CITY OF ALBUQUERQUE

RE: **Lot 32 Block 6 Volcano Cliffs Unit 18 SAD 228
6547 Pato NW
Grading and Drainage Plan
Engineers Stamp Date 8/21/2020 (D10D003M32)
Pad Certification Date 10/16/2020**

DRAINAGE AND TRANSPORTATION INFORMATION SHEET (REV 6/2018)

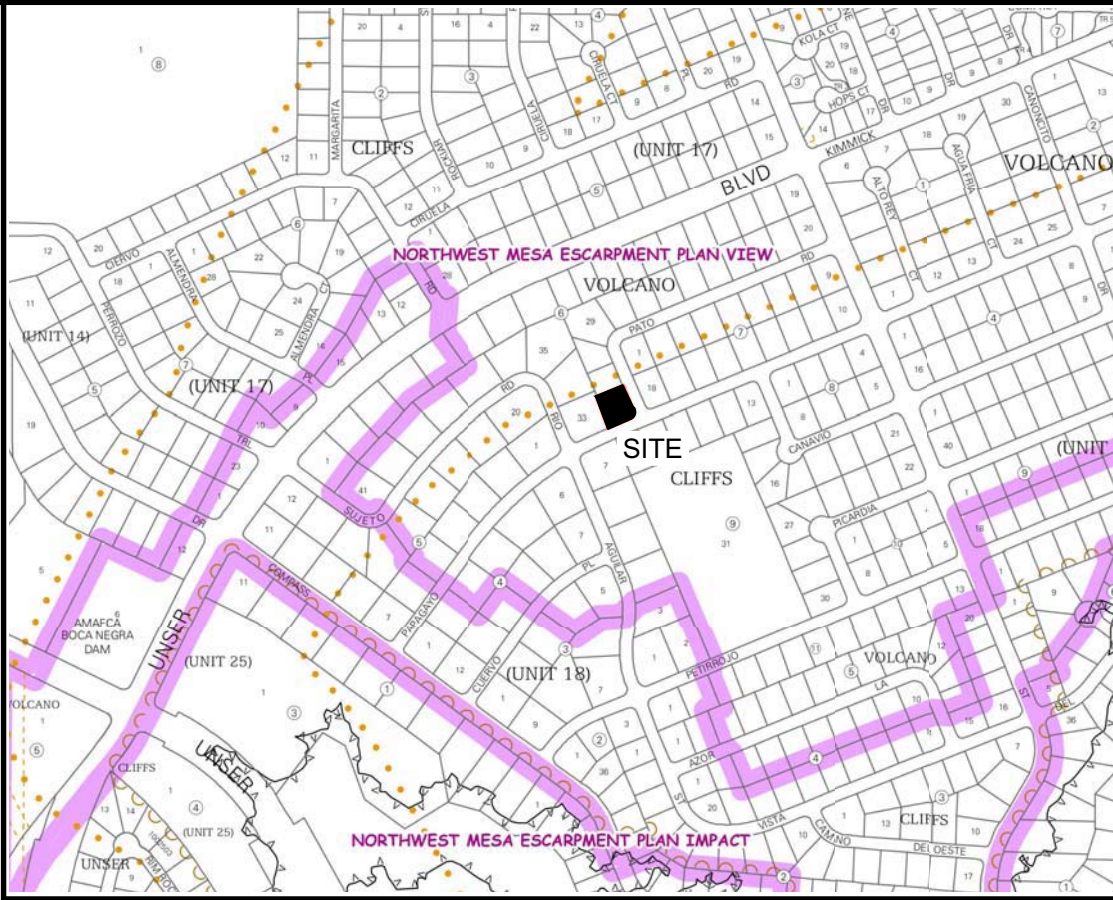
Based upon the information provided in your submittal received 10/20/2020, this plan is approved for Building Permit.

Reiterate to the Owner/Contractor that a separate permit for a garden/retaining wall must be obtained, with the approved G&D plan dated and Pad Certification.

Prior to Certificate of Occupancy release, Engineer Certification per the DPM checklist of this plan will be required.
